MINERALS PROGRAM INSPECTION REPORT

MINE NAME: Cross Gold Mine	MINE/PROSPECTING ID#: M-1977-410	MINERAL: Gold, copper, silver, zinc and lead	COUNTY: Boulder
INSPECTION TYPE: Preoperation Inspection	INSPECTOR(S): Amy Eschberger, Peter Hays	INSP. DATE: June 24, 2021	INSP. TIME: 10:00
OPERATOR: Grand Island Resources LLC	OPERATOR REPRESENTATIVE(S): Richard Mittasch, Daniel Pollock	TYPE OF OPERATION: 110(2) - Hard Rock Limited Impact

This was a pre-operation inspection of the Cross Gold Mine (Permit No. M-1977-410) conducted by Amy Eschberger and Peter Hays of the Division of Reclamation, Mining and Safety (Division) in response to an Amendment application (AM-2) filed with our office on February 8, 2021. The inspection was also partly conducted to observe the stabilization work completed on the slope above the Idaho Tunnel portal in relation to the Division's review of Technical Revision No. 9 (TR-9). The operator was represented during the inspection by Richard Mittasch and Daniel Pollock. The site is located approximately 4 miles northwest of Nederland, CO in Boulder County, at an elevation of approximately 9,760 feet. Access to the site is off of Caribou Road. A separate entrance

Project				DRMS Amendment 2			
Title				EXHIBIT E			
				Proposed Permit Boundary Modifications Potosi Mine Shaft and Caribou 300 Level			
		Project No. CO-0801		File No.			
		GIS:	JST	05/17/21	Scale As Shown	Rev 0	
		Check:	JST	05/17/21	Map 4		
		Review:	DP	05/17/21

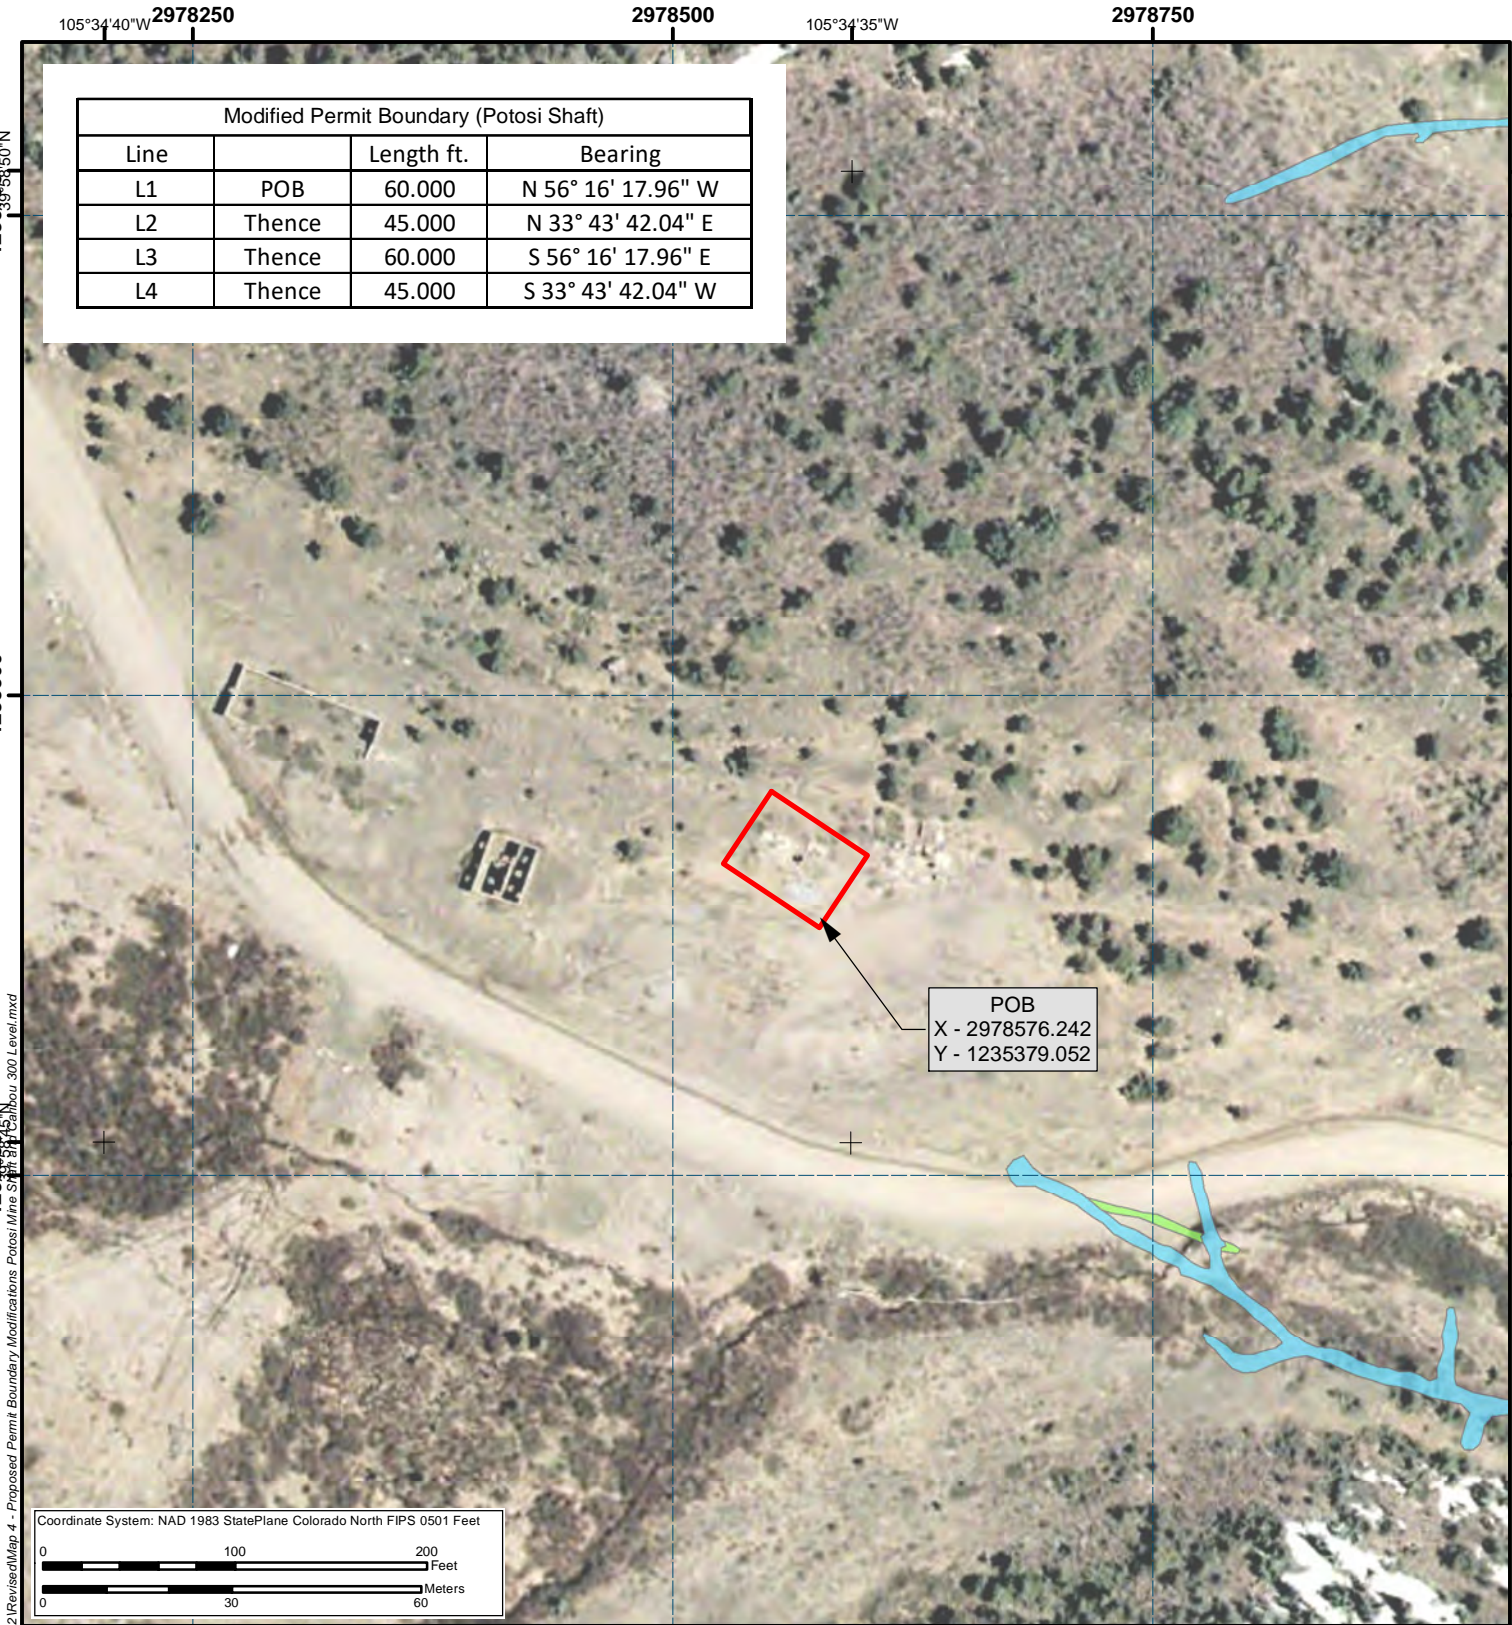
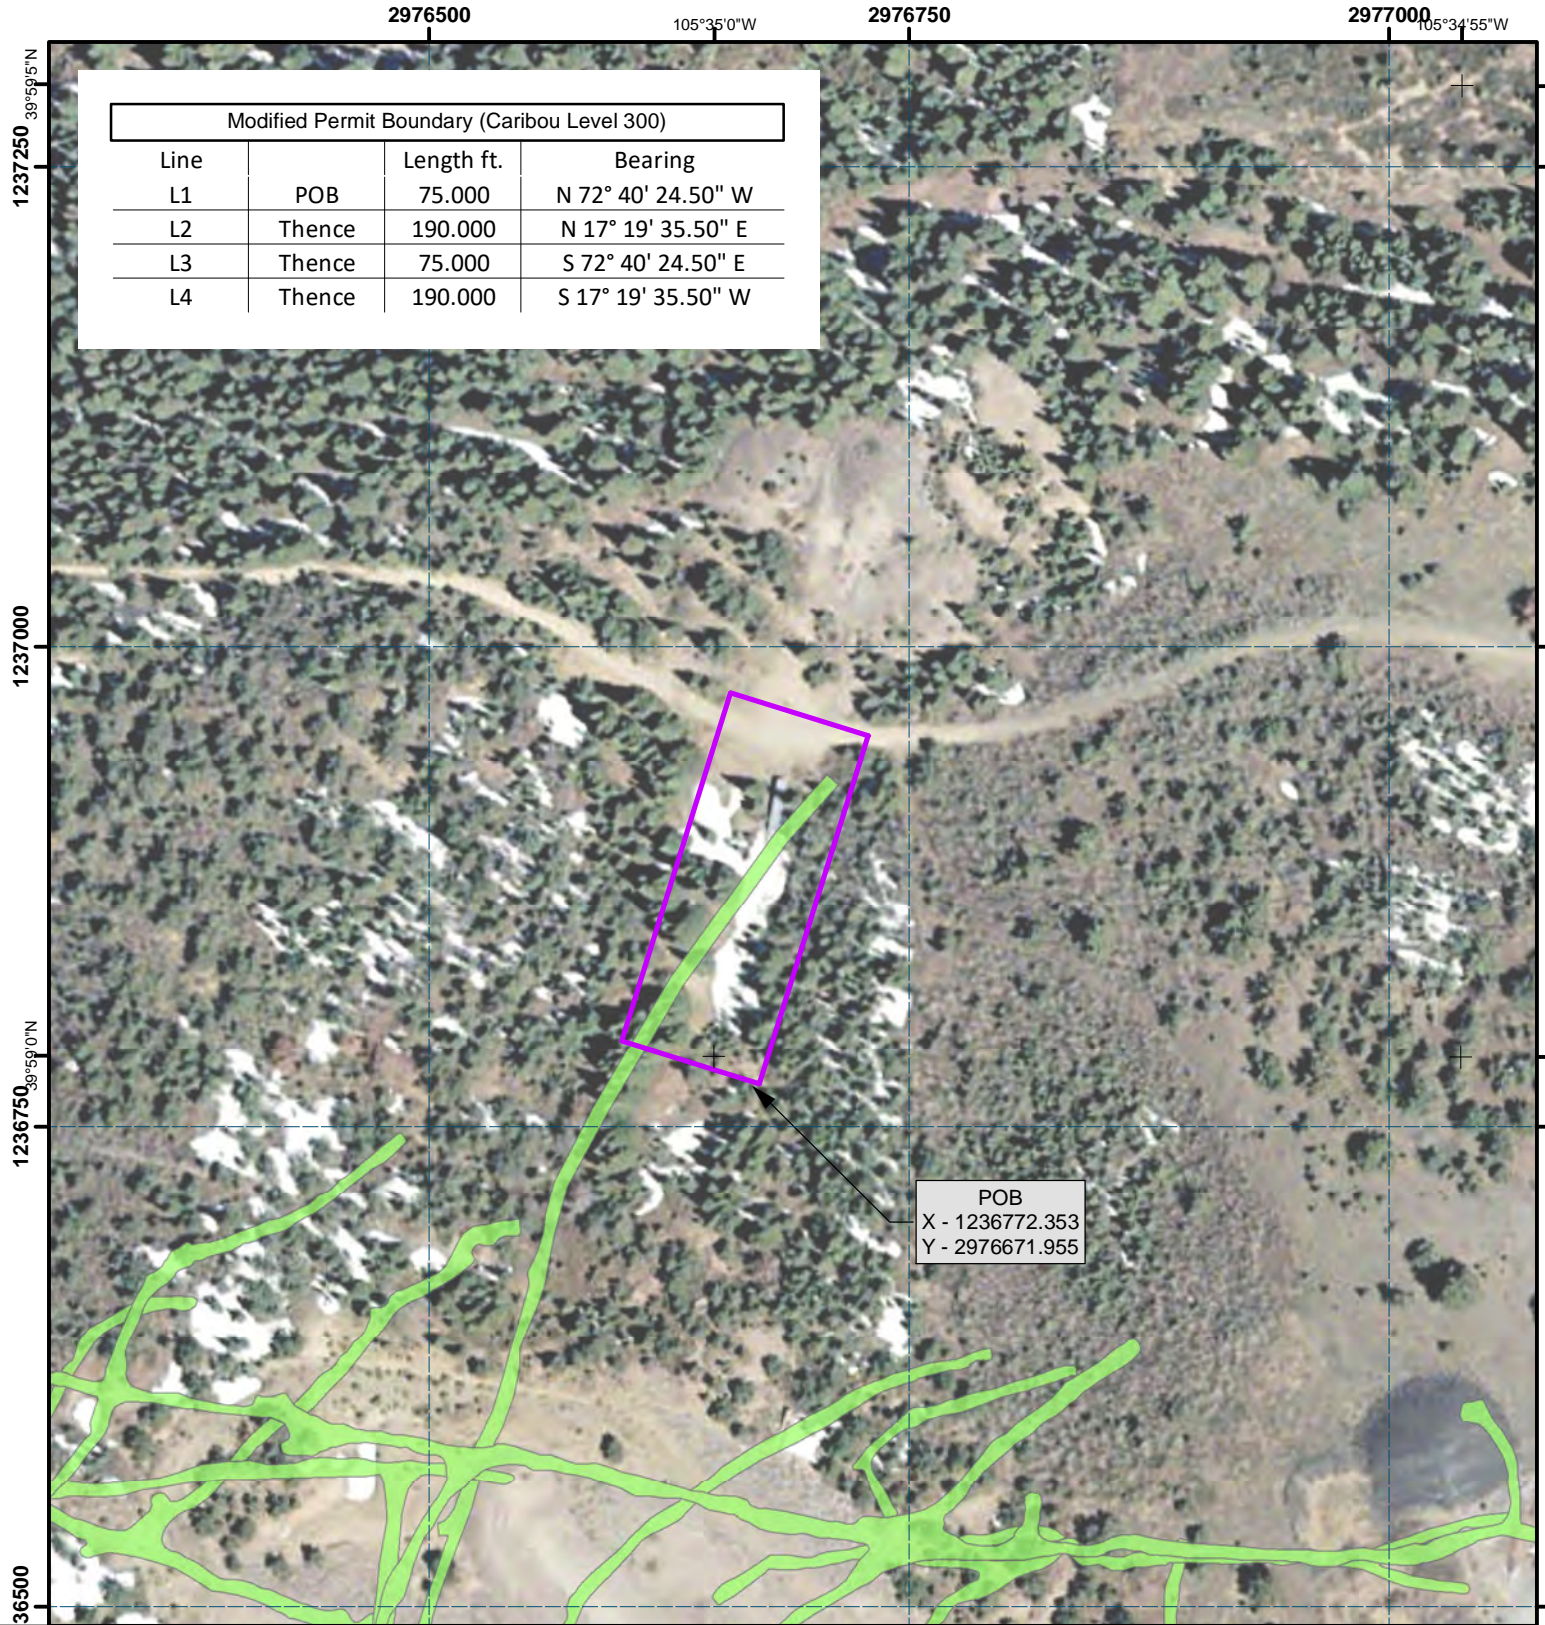
The Division inspected the proposed new permit area for the Potosi Shaft, located approximately 0.35 mile northwest of the Cross-Caribou site. AM-2 indicates this shaft will be used as an airway or secondary escape route. The shaft is located approximately 100 feet north of Caribou Road, on top of what appears to be an historic waste rock dump. The shaft is immediately enclosed by barbed wire, with chain-link fencing surrounding the entire shaft area. "Keep out" signs are posted on the shaft. AM-2 proposes a rectangular-shaped permit area of 0.06 acre for the Potosi Shaft area. The Division estimates the chain-link fencing surrounding the shaft to cover an area approximately 15 feet x 10 feet in size, which corresponds to 0.003 acre. Therefore, it appears the chain-link fencing does not delineate the proposed permit area. The operator will need to mark the permit boundary in this area with monuments or other markers that are clearly visible and adequate to delineate such boundaries in accordance with Rule 3.1.12(2). The Division observed some historical structures located in the Potosi Shaft area, including old concrete foundations and the remnants of two stone buildings. These structures were associated with the old mining town called Caribou that existed in the area in the late 1800's and early 1900's. All of these structures appeared to be located within 200 feet of the proposed Potosi Shaft permit area, except for the remnants of the larger stone building (to the west), which may be located just outside of the 200 foot radius. The operator will need to address these structures in AM-2, and provide a structure agreement for any structures not owned by the operator.

AM-2 states the Potosi Shaft will be accessed on foot (off of Caribou Road), and that no new road will be constructed in this area. During the inspection, the Division was unable to locate any existing roads in this area. However, in viewing aerial imagery of the site available in Google Earth, it appears there is a single-track trail off Caribou Road which runs east/northeast directly south of the stone building located closest to the Potosi Shaft and continues east/northeast to the shaft area. Apparently, this trail was mostly grown over by vegetation, making it difficult to locate during the inspection. The operator should be reminded that any existing roads requiring upgrading in support of the proposed operation would be considered affected lands pursuant to Rule 1.1(4).

The Division inspected the proposed new permit area for the Caribou Level 300 Portal, located approximately 0.9 mile northwest of the Cross-Caribou site. AM-2 does not clearly describe the intended use of this portal by the operation. The Division has requested additional information on the proposed use of this portal, as well as

any rehabilitation efforts that will be required for its use. The portal is located on the northeastern slope of Caribou Hill, just south of a USFS road. An historic waste rock dump is located across from the portal, on the north side of the USFS road. AM-2 proposes a long rectangular-shaped permit area of 0.33 acre for the Caribou Level 300 Portal area. During the inspection, the Division was unable to locate any markers delineating this proposed permit boundary. The operator will need to mark the permit boundary in this area with monuments or other markers that are clearly visible and adequate to delineate such boundaries in accordance with Rule 3.1.12(2).

AM-2 states a new road approximately 30 square feet in area will be constructed off the existing (USFS) road for access to the proposed Caribou Level 300 Portal permit area. This road will be regraded, tilled, and revegetated for final reclamation. It is not clear in the application where exactly this road would be constructed. It would seem the road would be constructed from the entrance of the snow shed to the adjacent USFS road; however, the proposed square footage does not seem to correlate with the road dimensions that would be required based on the distance between the snow shed and road observed during the inspection. The Division has requested additional information on this road, including its estimated dimensions and location. According to the Exhibit E maps provided in AM-2, the northern edge of the proposed Caribou Level 300 Portal permit area slightly overlaps the USFS road. If this is accurate, the operator will need to provide documentation of its legal right to enter any proposed affected lands owned by the USFS.
